**PUD &
SUBDIVISION STAFF REPORT****Date: June 16, 2005****APPLICANT NAME**

The Preserve Subdivision

DEVELOPMENT NAMEThe Lakes at the Preserve and
The Woodlands at the Preserve**SUBDIVISION NAME**

The Preserve

SITE PLAN

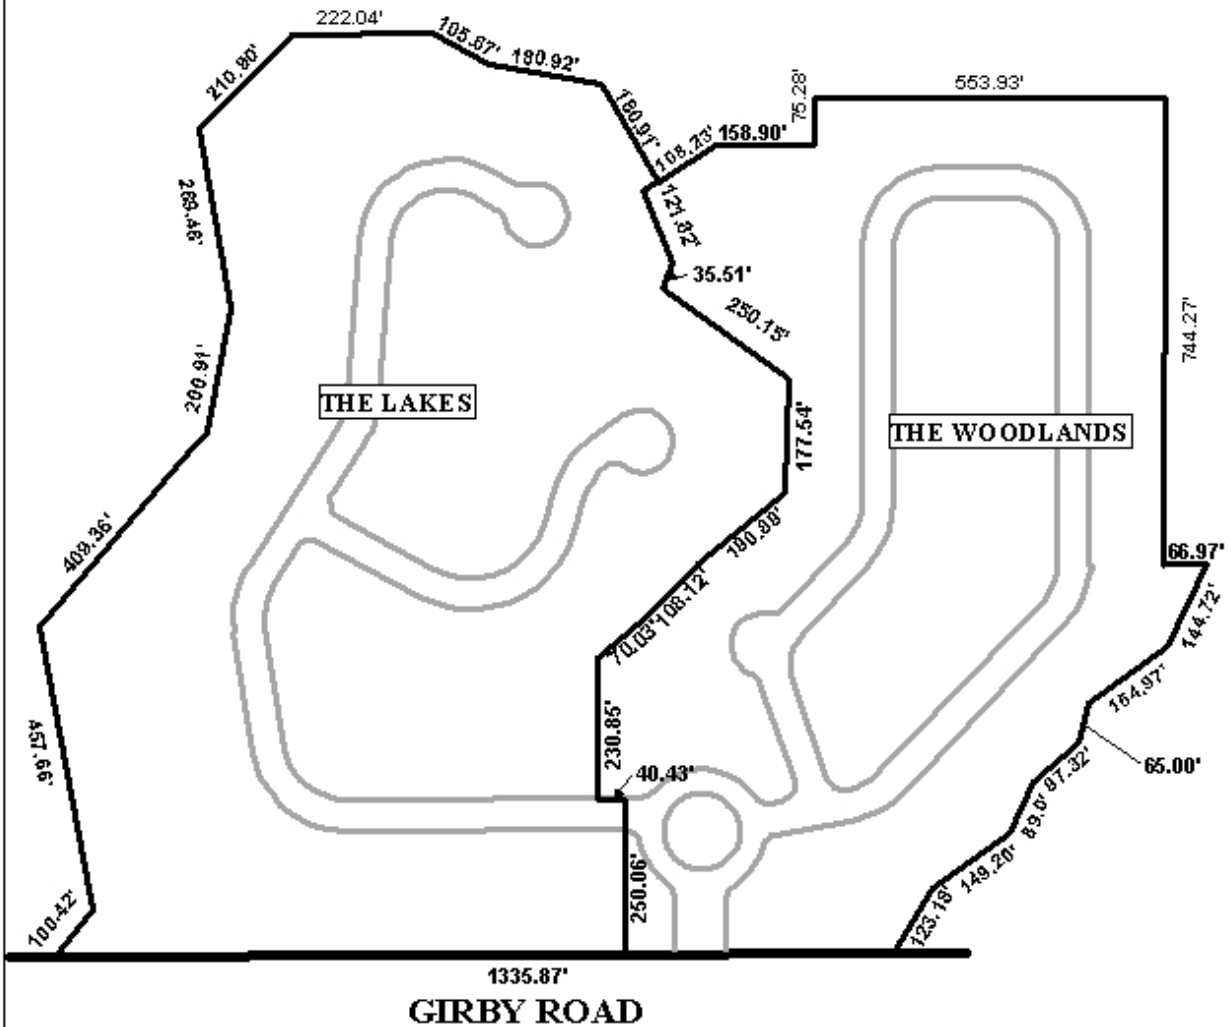
Existing street construction within the subdivision has caused flooding of Girby Road several times in the past months. The Developer's engineer must certify that the existing drainage system and outfalls can accommodate the proposed increase in coverage. In addition, detention for a 100 year storm with a 10 year discharge and/or outfall improvement may be required for any new development not already under construction. Any areas that discharge onto adjacent properties and not into a COM maintained system will require a hold harmless agreement. In addition, all stormwater detention should be accomplished above the AE Flood zone. Must comply with all stormwater and flood control ordinances. Any work performed in the right of way will require a right of way permit.

The applicant is requesting amendments to the previously approved PUD and Subdivision approvals. The proposed amendments do not alter the street layout, access, number of lots, density or site coverage (approved maximum of 45%), but rather incorporate areas that were originally Common Areas into the lots, and revise setbacks to comply with fire code requirements.

The site fronts Girby Road, a planned major street, which has an existing right-of-way of 80-feet; therefore, the dedication of adequate right-of-way to provide 50-feet from the centerline should be required. Additionally, a note should be placed on the final plat stating that access is limited to the one entrance road for the development. In terms of the subdivision request, many of the lots in the Woodlands are less than 50-feet wide and contain less than 7,200 square feet, thus a waiver of Section V.D.2., would be required.

Additionally, there are many large common areas within the development, and the placement of a note on the final plat stating that the maintenance thereof is the responsibility of the property owners would also be required.

As the site is adjacent to a creek, the area may be considered environmentally sensitive, thus the approval of all applicable federal, state and local agencies would be required.

Planned Unit Development: Based upon the preceding, this application is recommended for approval subject to the following conditions: 1) full compliance with the City Engineering Comments (Developer's engineer must certify that the existing drainage system and outfalls can accommodate the proposed increase in coverage. In addition, detention for a 100 year storm with a 10 year discharge and/or outfall improvement may be required for any new development not already under construction. Any areas that discharge onto adjacent properties and not into a COM maintained system will require a hold harmless agreement. In addition, all stormwater detention should be accomplished above the AE Flood zone. Must comply with all stormwater and flood control ordinances. Any work performed in the right of way will require a right of way permit); 2) the approval of all federal, state and local agencies; 3) that a minimum of 10-feet of separation be provided between buildings; and 4) full compliance with all municipal codes and ordinances.

Subdivision: Based upon the preceding, it is recommended that Section V.D.2 be waived and the plat granted Tentative Approval subject to the following conditions: 1) full compliance with the City Engineering Comments (Developer's engineer must certify that the existing drainage system and outfalls can accommodate the proposed increase in coverage. In addition, detention for a 100 year storm with a 10 year discharge and/or outfall improvement may be required for any new development not already under construction. Any areas that discharge onto adjacent properties and not into a COM maintained system will require a hold harmless agreement. In addition, all stormwater detention should be accomplished above the AE Flood zone. Must comply with all stormwater and flood control ordinances. Any work performed in the right of way will require a right of way permit); 2) dedication of any right-of-way necessary to provide 50-feet from the centerline of Girby Road, a planned major street; 3) that the site be limited to the one entrance road as shown on the plat submitted; and 4) the approval of all federal, state and local agencies;
